When replying please refer to:
TRAIL RIDGE MV 1-23 WATER IMPOUNDMENT DAM
AKA Williams Fresh Water Pit Dam
Water Division 5, DAMID: 390128

RE: Approval of Plan to Alter Dam to a Non-Jurisdictional Size:

RE: Williams Production RMT Fresh Water Pit Dam - Garfield County, Colorado
DAMID 450128 WD 5, District 45

**Williams Production RMT
Trail Ridge MV 1-23 Water Impoundment Dam
Schematic Site Plan - Sheet 1 of 2**

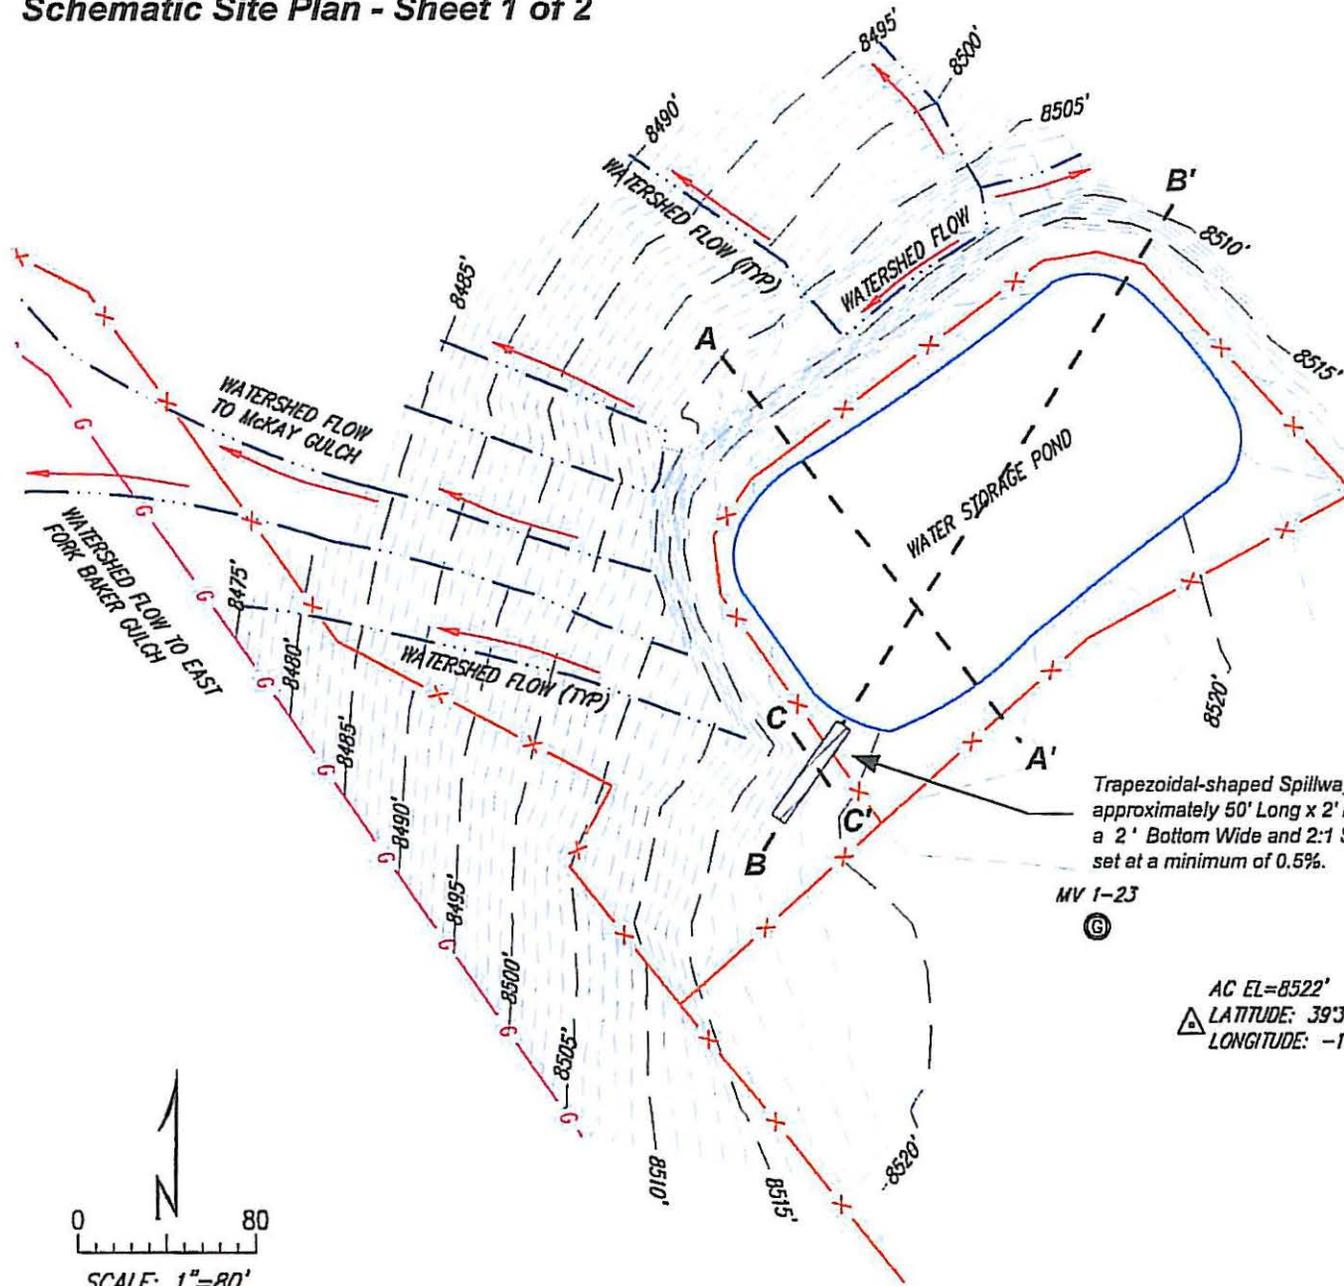
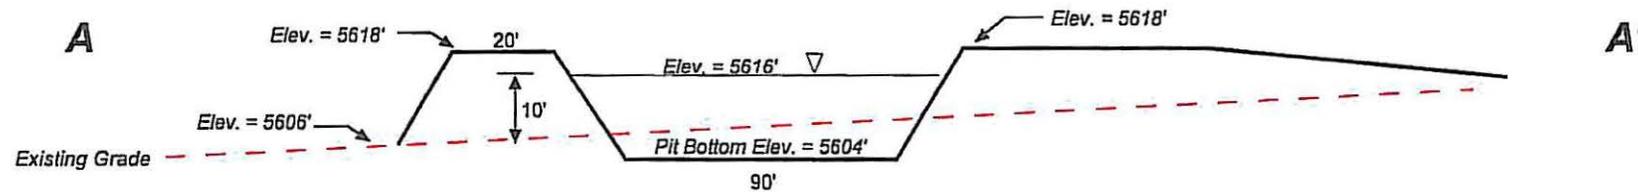
As per our discussion and your email correspondence of April 9, 2008, Williams is proposing to locate the spillway for the subject dam on the southwest corner of the site. This will put the spillway in an area of cut or undisturbed native material which will eliminate erosion threats to the dam embankment. Plan and cross section views of the structure and proposed spillway are attached as Sheets 1 and 2.

The proposed spillway, as shown on the drawings, is a trapezoidal-shaped channel with 2:1 side slopes approximately 50 ft. long by 2 ft. deep with a 2 ft. bottom width and is set at a 0.5% slope. Should the inflow pump malfunction and the 100-year 6-hour precipitation event occur simultaneously, the total estimated discharge through the spillway is 0.69 cfs. Utilizing the Manning-Chezy open channel flow formula, the proposed spillway will have a flow depth of 0.35 ft at the projected maximum discharge of 0.69 cfs. Formula input parameters, capacity and calculation results are tabularized on Sheet 1 of 2.

Thank you for submitting for our review the plan to alter the Trail Ridge MV 1-23 Water Impoundment Dam to a non-jurisdictional size. The submittal, including a written letter of intent along with support drawings and calculations for the proposed spillway, to alter the dam to a non-jurisdictional size were provided under the provisions of Rules 11.2.2 and 6.1.3 of Colorado's "Rules and Regulations for Dam Safety and Dam Construction". We have completed our review of the documents and have found them to be acceptable for construction. We are accepting the documents by letter in accordance with the provisions of Rule 6.A.(3) of the Rules and Regulations. Our acceptance and approval of the documents are effective as of the date of this letter with the following contingency. The construction oversight of the proposed alteration and improvements should be performed by Fox Engineering Solutions.
